**RE: San Roque / La Serena
441 & 457 Coors Blvd NW
Grading & Drainage Plan and Drainage Report
Engineer's Stamp Date: 11/10/21
Hydrology File: J10D049**

**RE: RESPONSE TO HYDROLOGY COMMENTS
SAN ROQUE / LA SERENA
441 & 457 COORS BLVD NW
GRADING & DRAINAGE PLAN AND DRAINAGE REPORT
HYDROLOGY FILE: J10D049**

**San Roque & La Serena Developments
Albuquerque, NM**

PROPOSED BASIN MAP

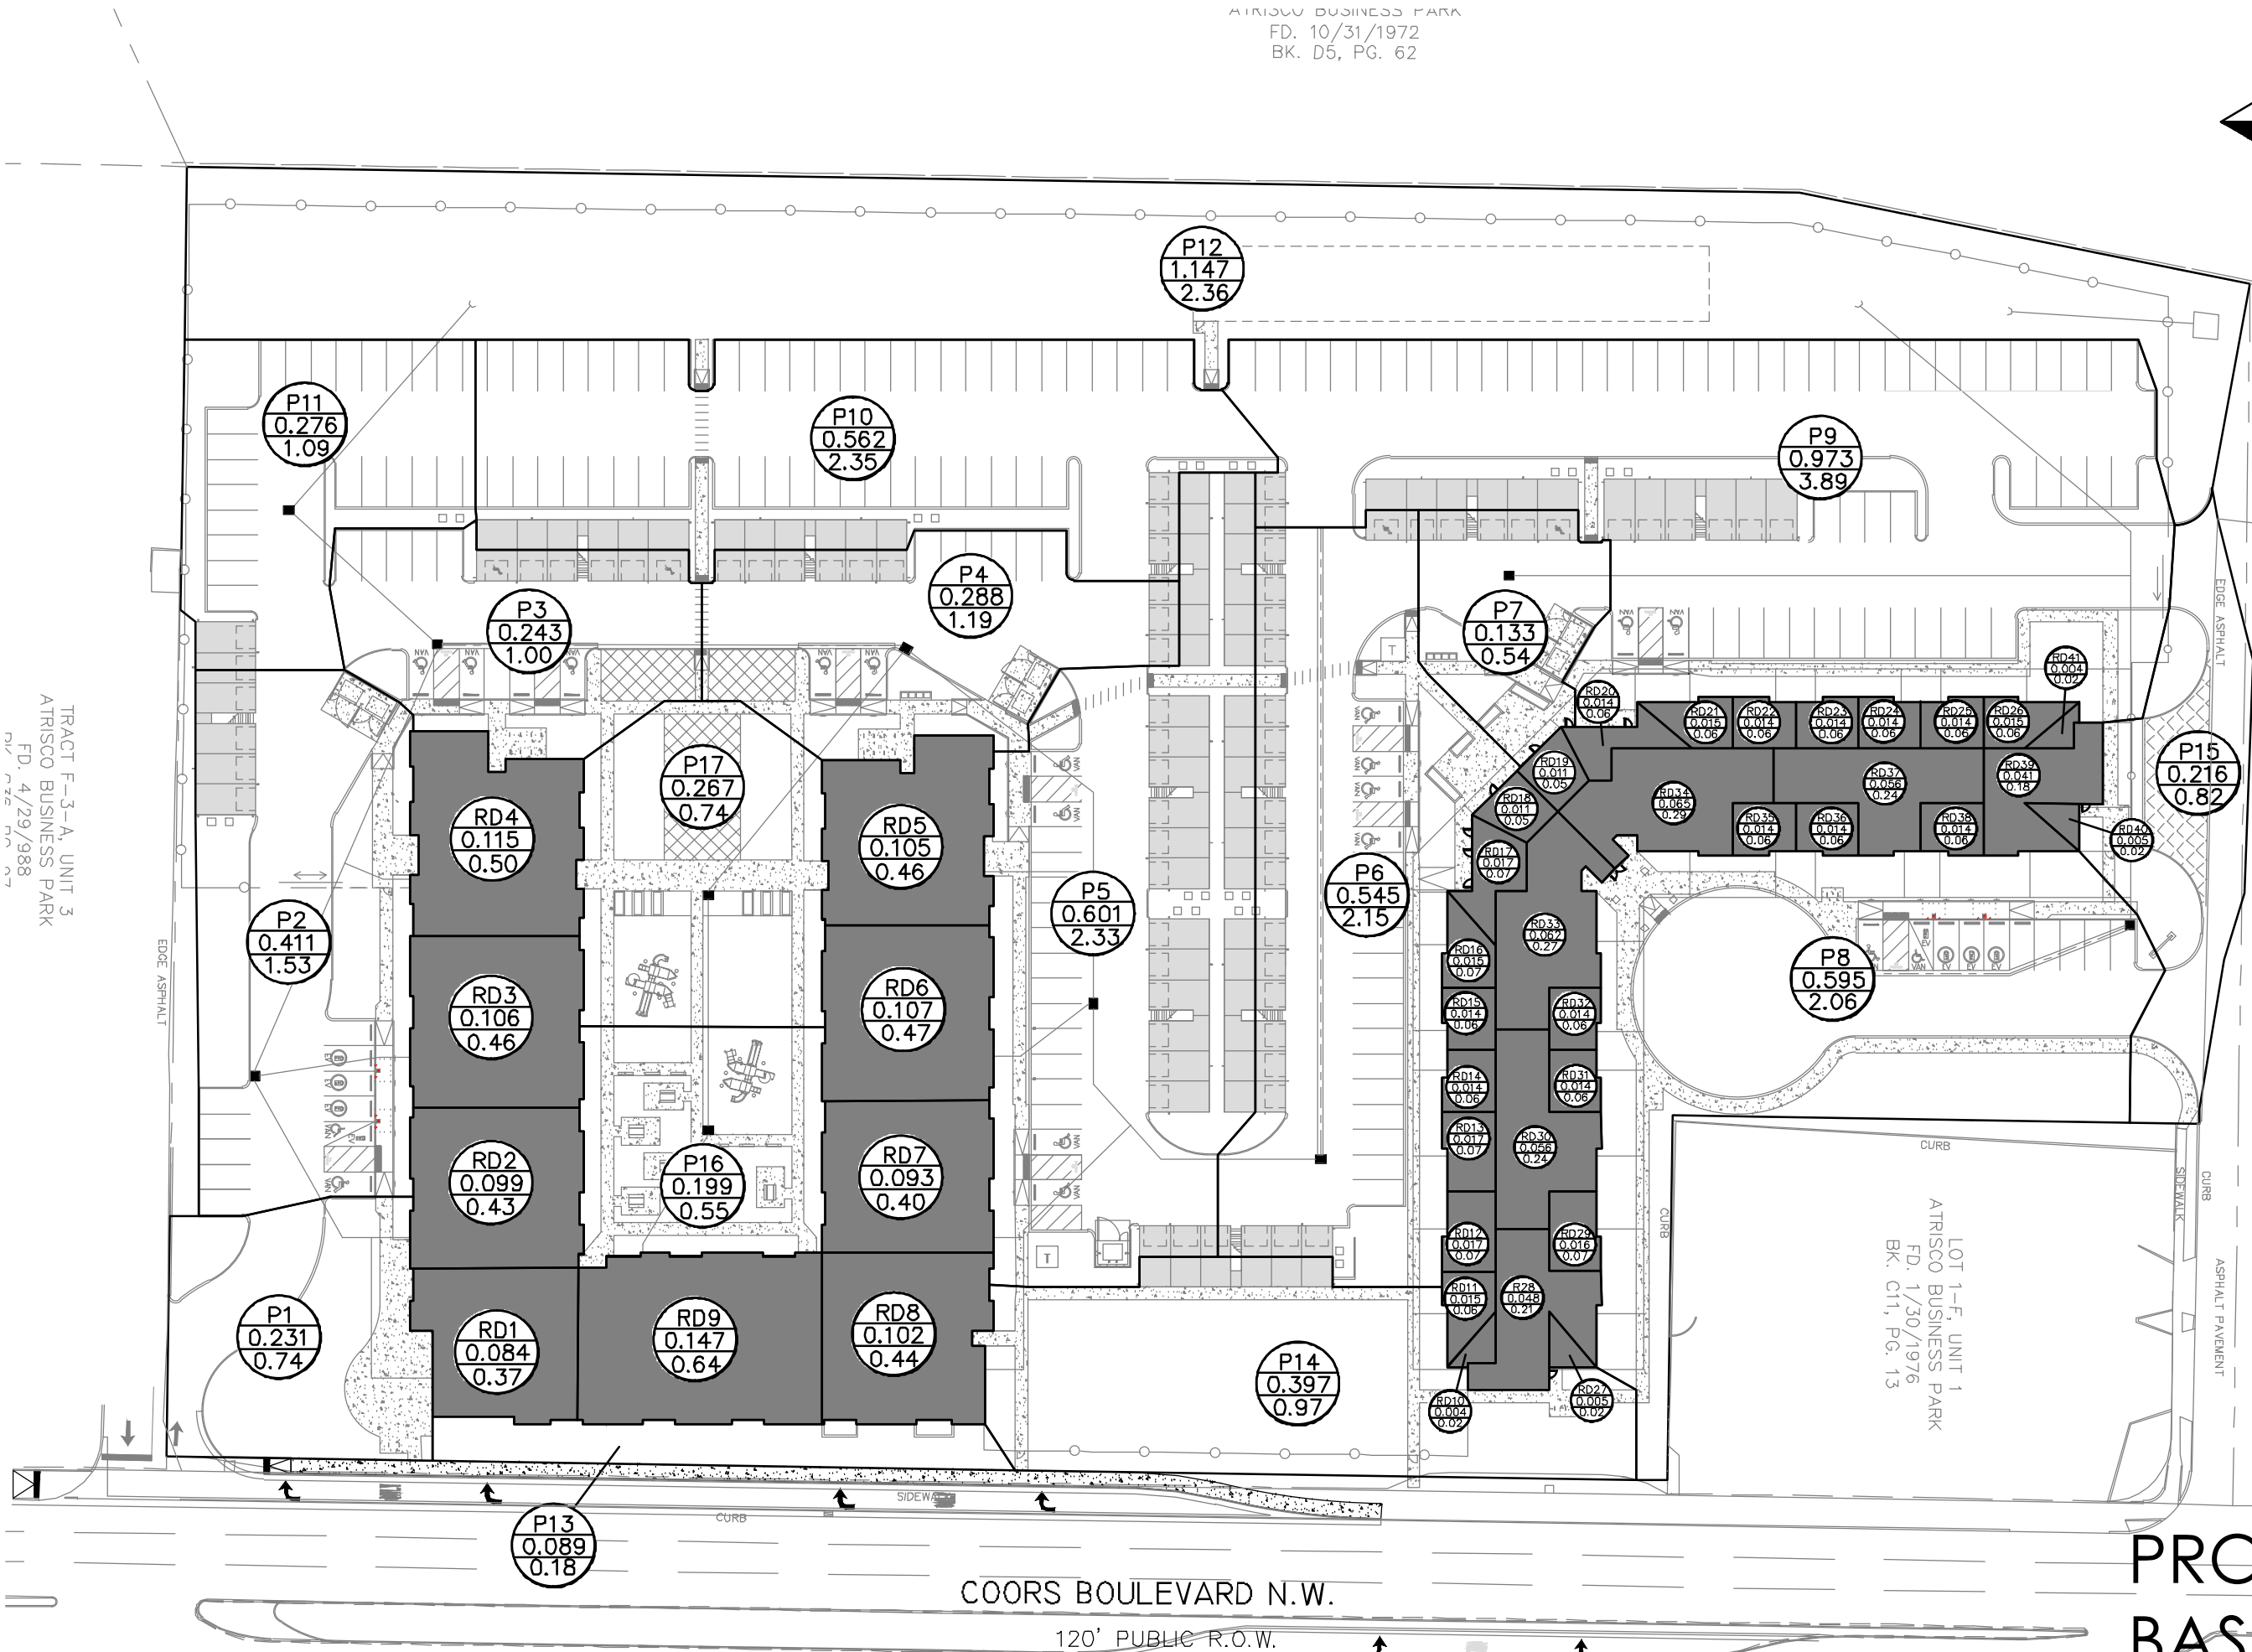
1. Under Existing Conditions, the report states, "This site lies within the Atrisco Business Park Master Plan..." This is false, below is the basin map from the report and this site is not in the report area. However as noted, the exiting 60-in public storm pipe stops on the project's site without any City's plans to extend the storm system. Therefore this site will be able to freely discharge into this existing 60-in with no problem since there is plenty of capacity. Please discharge into a revised stormwater quality pond prior to the connection this existing pipe. (see below for the as-builts of that existing 60-in pipe)

Response: The Existing Conditions section of the drainage report has been modified for removing discussion about the site falling within the Atrisco Business Park Master Plan. The Existing Conditions section now states that due to the capacity of the existing 60-inch public storm pipe, the site will be allowed to free discharge into this storm pipe.

c2.1

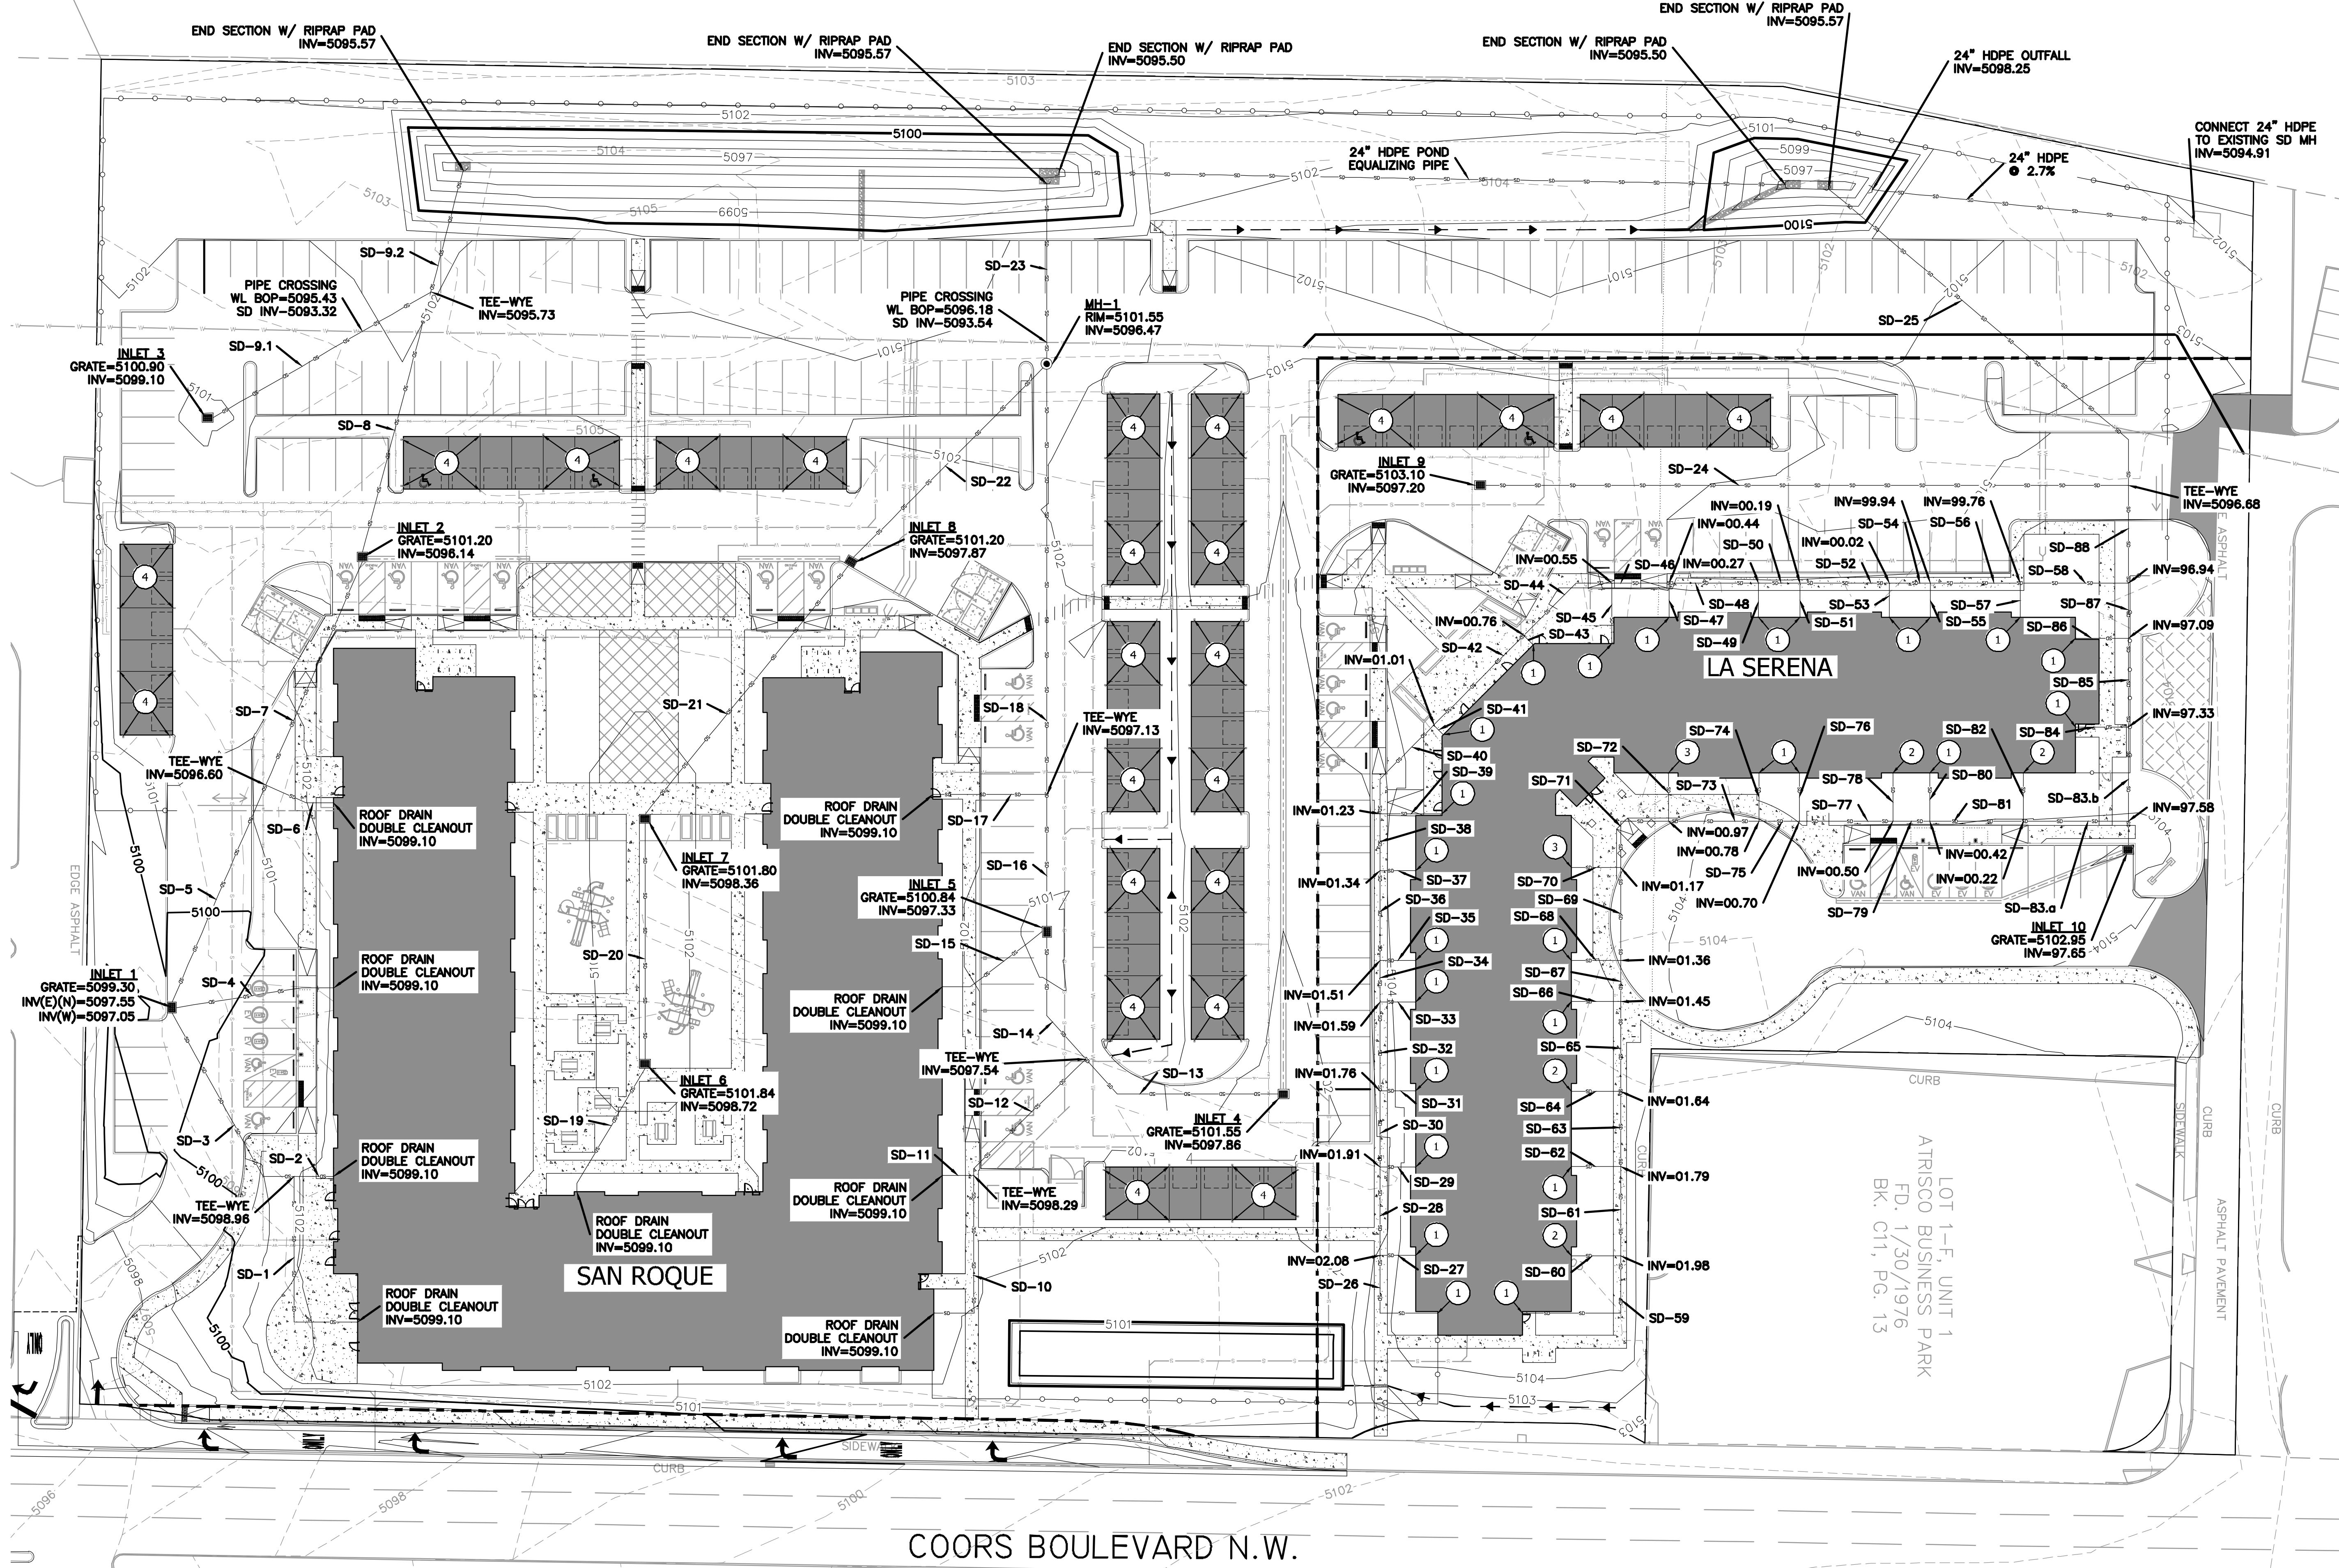
4. Sheet 2.1 & 2.2. Please add what kind of spot elevations these are. (i.e. top of curb, flow line, or top of pavement).

5. Sheet 2.1. & 2.2. Please add the top of grate elevation where there is a grate. It is hard to keep turning to the storm pipe sheet for that information.

6. Sheet 2.1. I noticed that the existing asphalt is cracked and not completely straight as shown in the photo below. Please show where there will be a saw cut on the existing pavement. Also please indicate the existing top of pavement along the saw cut. Since this work is also on the adjacent property, please provide a notarized letter stating that this work can be done by that property owner. Also please provide the top of curb information at the end of the radius on this drive entrance.

Response: A spot elevation note has been added to each of sheets 2.1 and 2.2 stating "All spot elevations shown are flowline/bottom of curb unless otherwise noted."

Response: Sheets 2.1 and 2.2 now show top of grate elevations for any inlet that is called out onsite.

Response: Sheet 2.1 now shows where the sawcut line will be in the existing asphalt with top of existing asphalt grades shown. Due to recent discussions with NMDOT and the adjoining Bank of Albuquerque representatives, the entrance to San Roque has changed to be a shared access at Coors Blvd. The sawcut and existing asphalt removals will be limited to constructing this new driveway entrance. Both the adjoining bank and developer are amenable to the current shared access layout as proposed and we are currently working on executing and recording a shared access easement straddling both properties and against the Coors ROW for these improvements. The DRB will not fully sign-off on an approved Site Plan until we have this shared access easement fully executed and recorded.
